MILITARY SPECIFICATION

WARHEAD, GUIDED MISSILE, H.E., M207E2
LINER FOR

This Amendment forms a part of Military Specification MIL-W-63451 (AR) dated 17 June 1981 and is approved for use by the U.S. Army Armament Research and Development Command and is available for use by all Departments and Agencies of the Department of Defense.

MIL-W-63451
AMENDMENT 3

FIG. 1

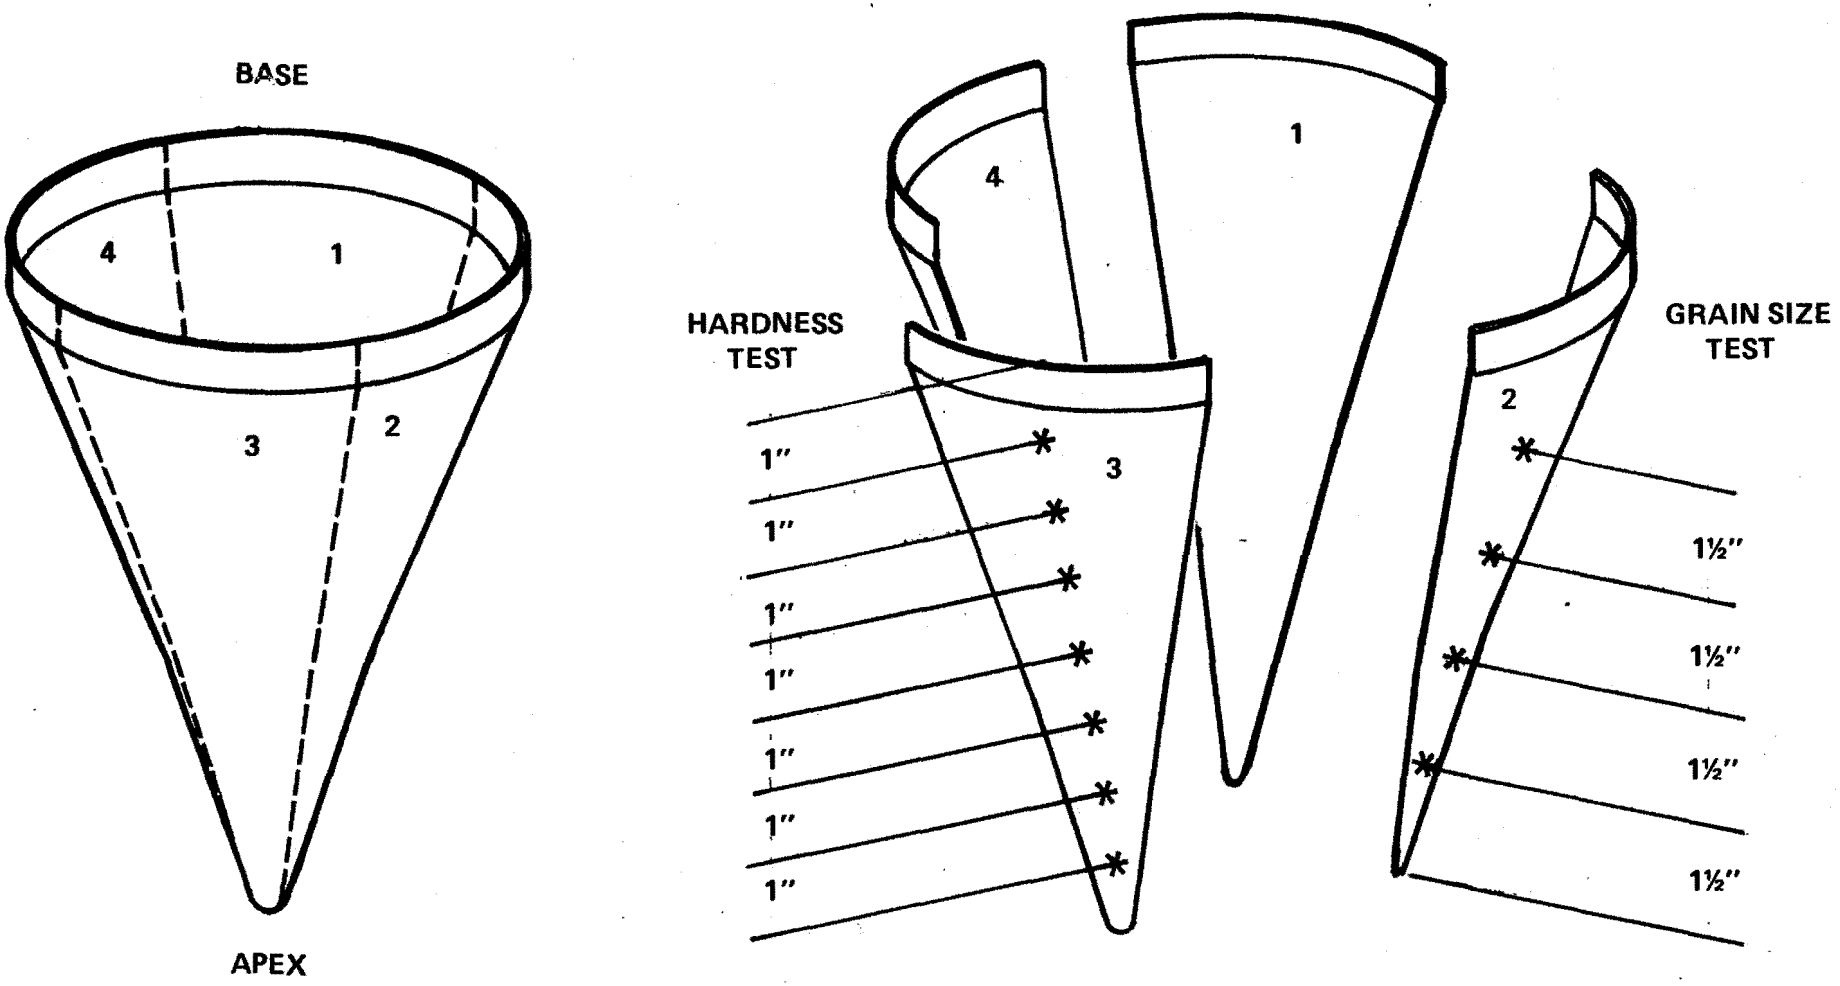
4.5.2.4 Hardness of finished liner. The sample liners shall be sectioned longitudinally into four equal parts and marked for exact location relative to the finished liner. The Rockwell F hardness readings shall be taken one-inch from the base and every one inch thereafter in a longitudinal direction, from base to apex, for seven readings on each section. (See Fig. 1) A total of twenty-eight readings shall be taken for the finished liners. The hardness readings shall be identified as to their location on the liner. The recorded readings shall be analyzed for variations in hardness in both the longitudinal and circumferential directions. If any of the sample liners do not meet the hardness requirement specified on the drawing, the liner heat treat batch represented by the samples shall be rejected. The hardness test data shall be submitted in accordance with DI-T-5247 (Tailored) (See 6.4). This is a destructive test.

4.5.2.5 Grain size of finished liner. A test section from 4.5.2.4 shall be utilized for taking grain size. Grain size shall be taken on one of the quartered sections in a longitudinal direction 1 1/2-inch from the apex and 1 1/2-inch apart from each other for a total of four readings per sample liner. (See Fig. 1) If any of the sample liners do not meet the grain size requirements as specified on the drawing, the liner heat treat batch represented by the sample shall be rejected. The grain size test data shall be submitted in accordance with DI-T-5247 (Tailored) (See 6.4).
